Concept Plan for the Renovation of Long Branch-Wayne Local Park

PUBLIC OUTREACH

Long Branch-Wayne LP Renovation Project

Community Meeting #1 – March 8, 2016

Concept 3

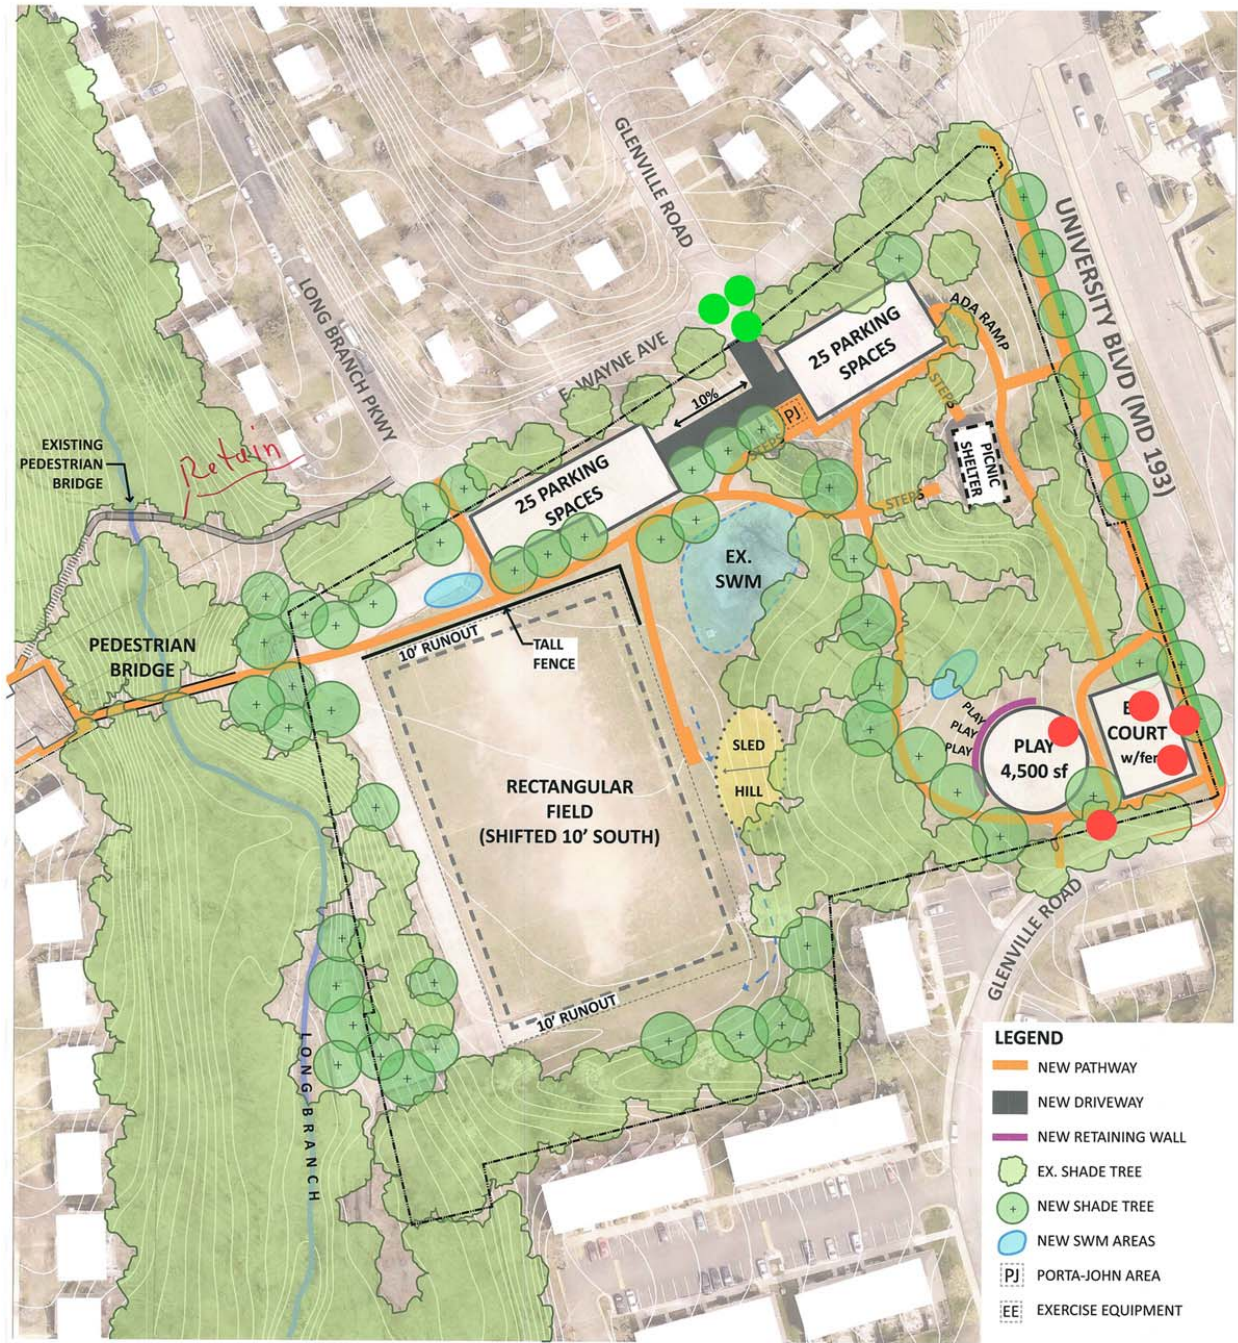
Play areas too distant from community parking
